UNITED STATES PATENT AND TRADEMARK OFFICE

10/814,797

Office Action Summary

DETAILED ACTION

Solak '874 Figures 1 and 2

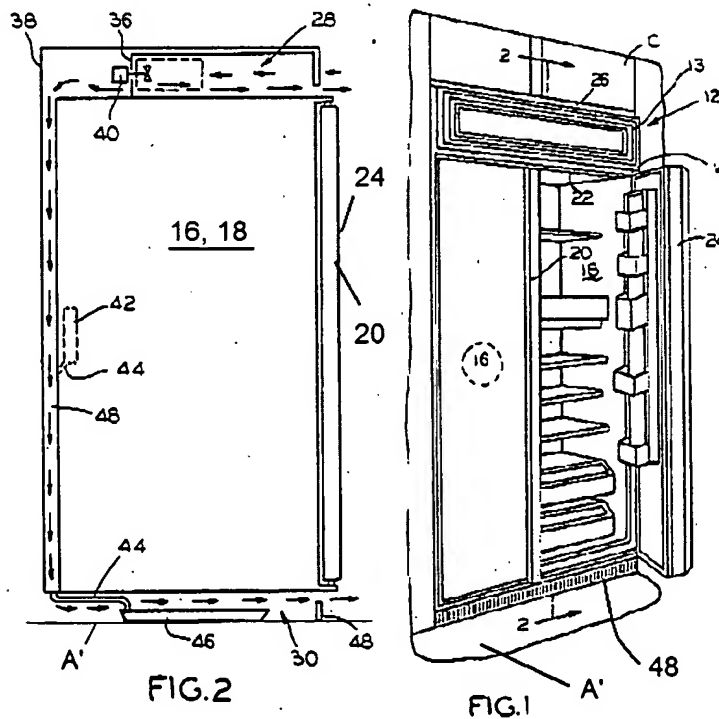
13. Claim 7 is rejected under 35 U.S.C. 102(b) as being anticipated by US Patent 4,970,874 to Solak. Solak teaches a built in refrigerator in parallel to an lower adjacent structure (A') and an upper adjacent structure (C). The refrigerator comprises a housing (38) internally defining a space (16,18) and a door (20,24) hingebaly coupled to the housing to open and close the space. The center of hinging movement (axis of rotation) of the door is positioned outside of the housing as seen in figure 2. A machine room (28) is at the top portion of the housing and has a machine room door (13). A grill (64) is behind the machine room door and protects the machine room (28). The refrigerator further comprises a spacing member (48), which defines a constant gap between the housing and the lower adjacent structure (A').
